**United States Department of the Interior
Bureau of Land Management**

Decision Record
for
**Revised Environmental Assessment
DOI-BLM-CA-D050-2013-042-EA**

**A Modification of
Plan of Operations (POO) CACA-45475**

Applicant:
**Bronco Resources, Inc. of
Canyon County, CA**

BLM Manly Fall wilderness map.

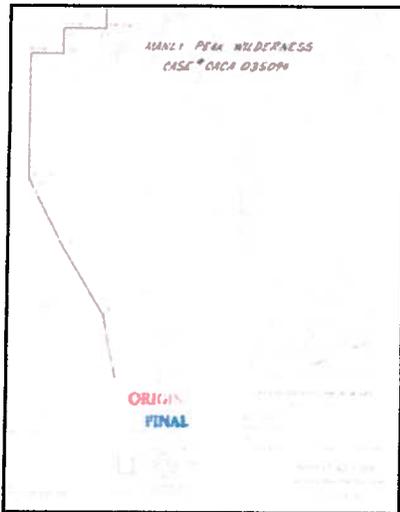
Comment 12. Wilderness Boundaries. Comprehensive map needed.

Section 3.10, page 19, and 4.9, page 31 discuss boundaries of the Manly Peak Wilderness.

Please refer to the below graphics of the area of the southern group of drill locations.

My annotated map indicates that some proposed drill locations are very close to the wilderness boundaries. This map only indicative, and certainly not definitive.

- The wilderness boundary in the vicinity of the drill holes north of Coyote Canyon must be surveyed to determine its exact location.
- The surveyed wilderness boundary, the drill hole locations, and the Briggs permit area must be stated clearly and accurately in the EA (using NAD27 UTM coordinates, see comment below), and shown on an accurate map included in the EA. To be complete and provide all pertinent related information, the Bronco claim boundaries should also be shown. Note that the claim names are listed on page 6, but are located only with Township, Range and Section.
- Any drill locations found to be inside Wilderness, or so close that drilling would disturb Wilderness, must not be drilled, or must be relocated out of wilderness.

Figure 2. Project area overview and drilling locations.

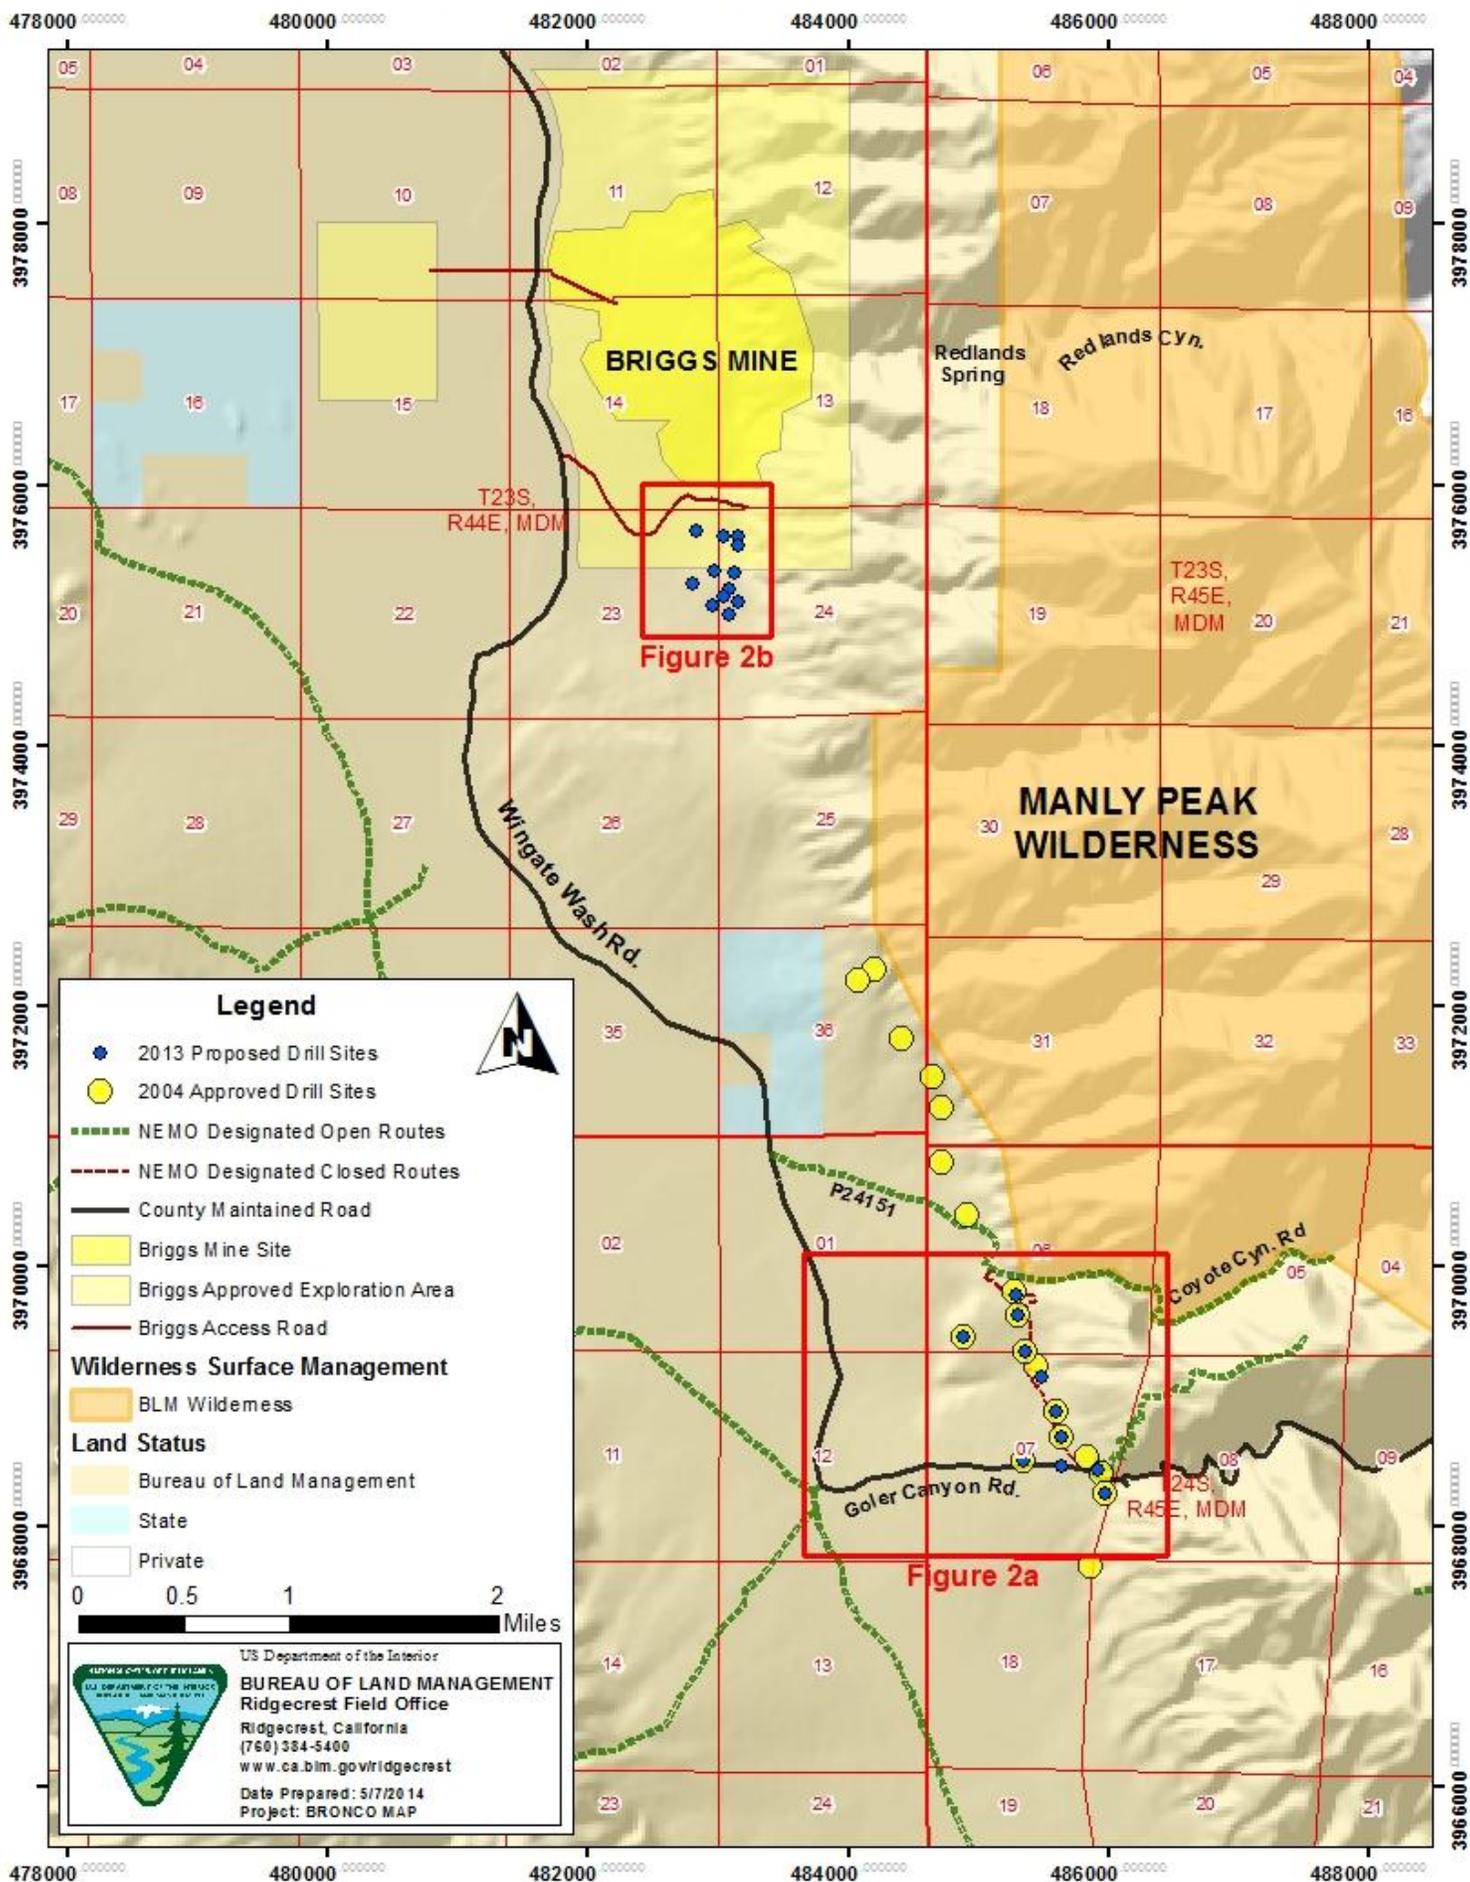
4. Maps – figures 2, 3 and 4 on pages 6, 7, and 8, do not show, or show with insufficient detail, nearby land management status for adequate review.
 - The scale of the map on figure 2 is too large to judge proximity of the proposed drill holes to the Briggs permit area.
